Valve Timing Changes – AJ16 Engine

MODEL 1995-96 MY  
4.0 NA  
VIN 720001-ON

ILLUSTRATION 1

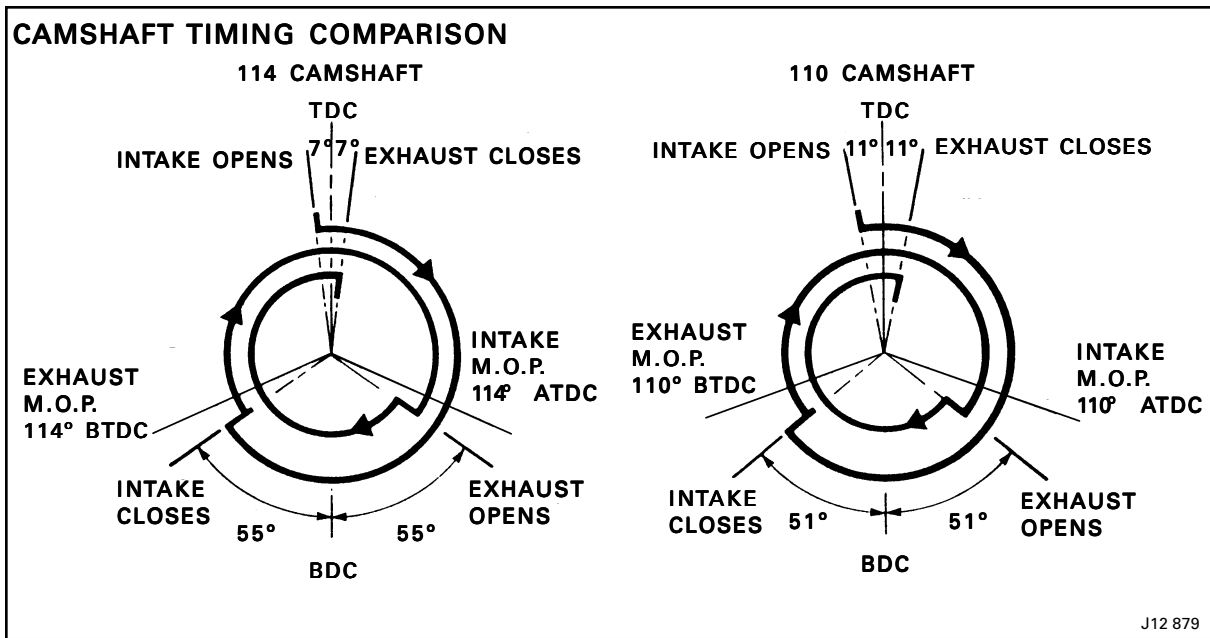
To improve idle quality, revised camshafts with reduced valve timing overlap were introduced on the normally aspirated engines as running change 95/13.

The original camshafts, with a maximum opening position of 110 degrees have been superseded by camshafts with a maximum opening position of 114 degrees. This change is accomplished by machining the camshaft slot in a different

position. The valve timing overlap is reduced from 22 degrees on the 110 camshafts to 14 degrees on the 114 camshafts, Illustration 1.

The maximum opening position of the 114 intake camshaft is 114 degrees after top dead center (ATDC) while the maximum opening position of the exhaust camshaft is 114 degrees before top dead center (BTDC).
